NEIGHBORHOOD ENGAGEMENT

Spoede Woods

Areas of Concern

Proposed Retaining Walls

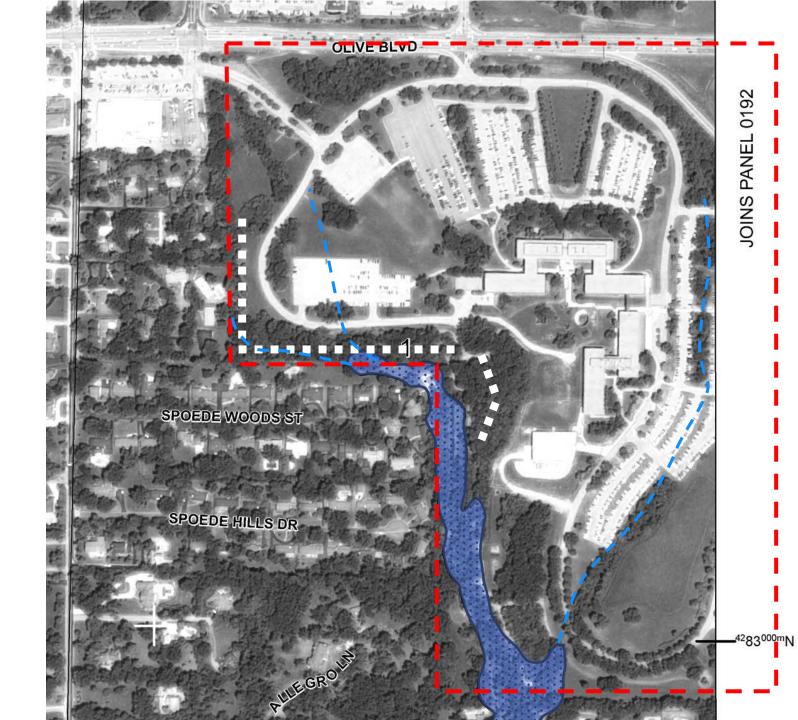
Effect of New Retaining Walls?

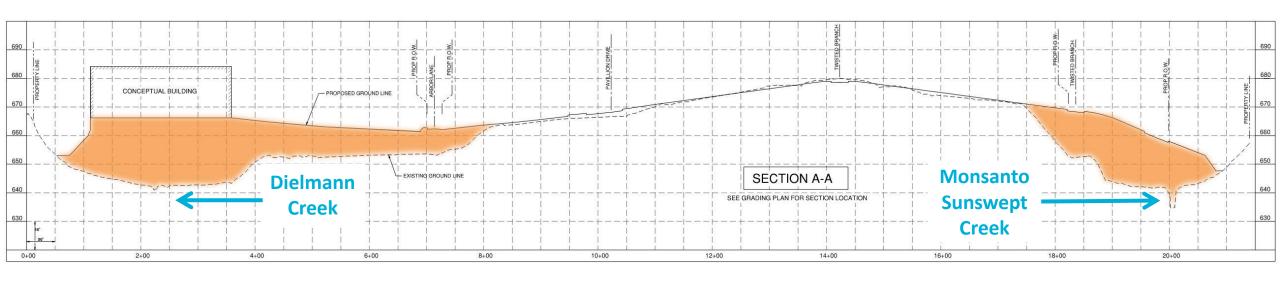
Impact of Proposed Regrading?

Dielmann Creek

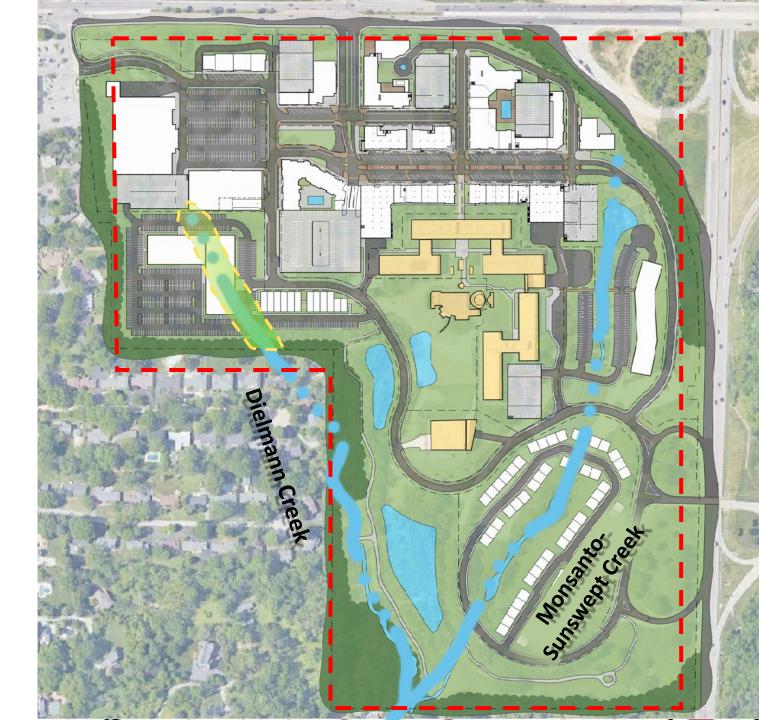
25' Stream Buffer required.50' setback for impervious cover.

No buildings, pavement, or structures are allowed within 50' of a stream course.

RETAINING WALLS

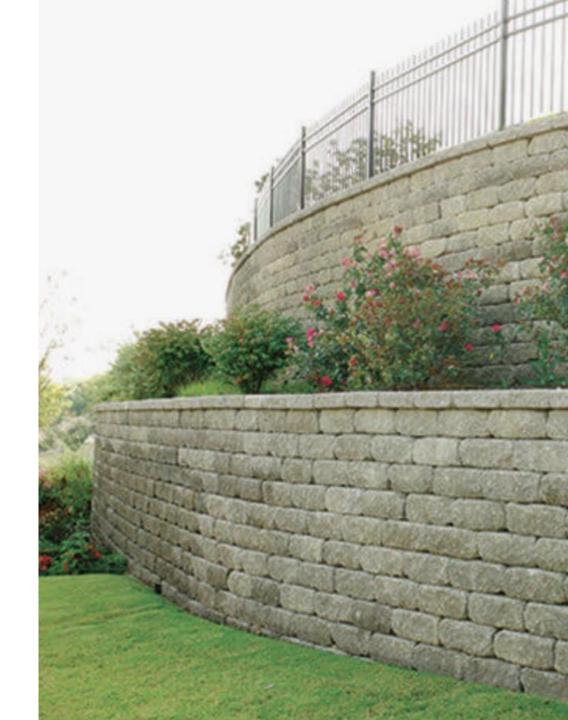
6' Maximum

"Steeper grades are allowed if... the excavation or fill is protected by a properly designed ... retaining wall approved by the Zoning Administrator. Such walls shall not normally exceed a height of six (6) feet." Creve Coeur Land Development Standards, Section 410.270

Tree Preservation

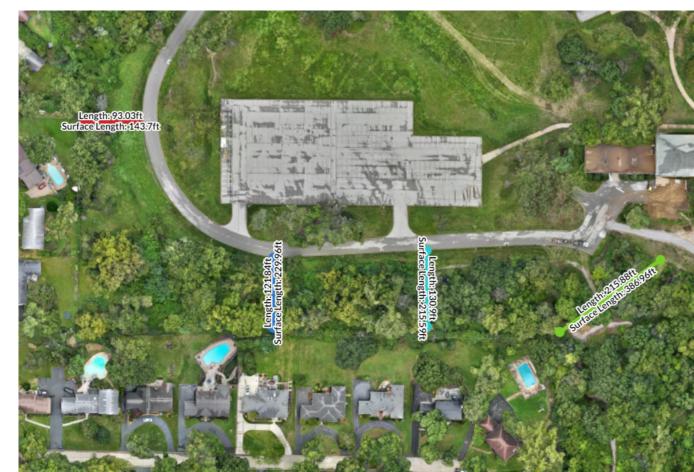
Under the current plan, hundreds of mature trees will need to be removed to make way for the retention basins.
